# S4.55 MOD.PL

DRAWING No.: DA:06

project:  
No. 65 KELVIN PARADE,  
PICNIC POINT.  
LOT 25 DP 13775 - SITE : 486.9sqm  
client:  
MR & MRS DOUENI  
GROUND FLOOR

# GROUND FLOOR LAYOUT

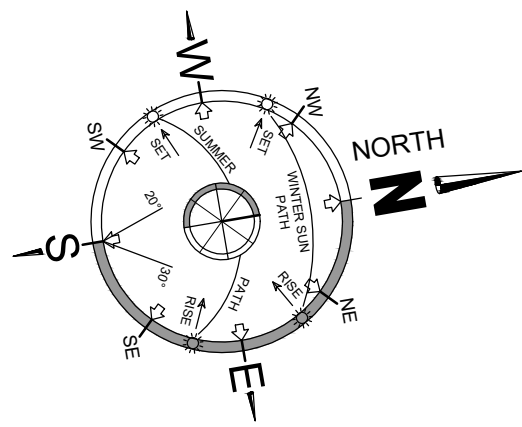
RELOCATED POOL FILTER/PUMP TO ALLOW FOR GREATER FUNCTION OF PRIVATE OPEN SPACE
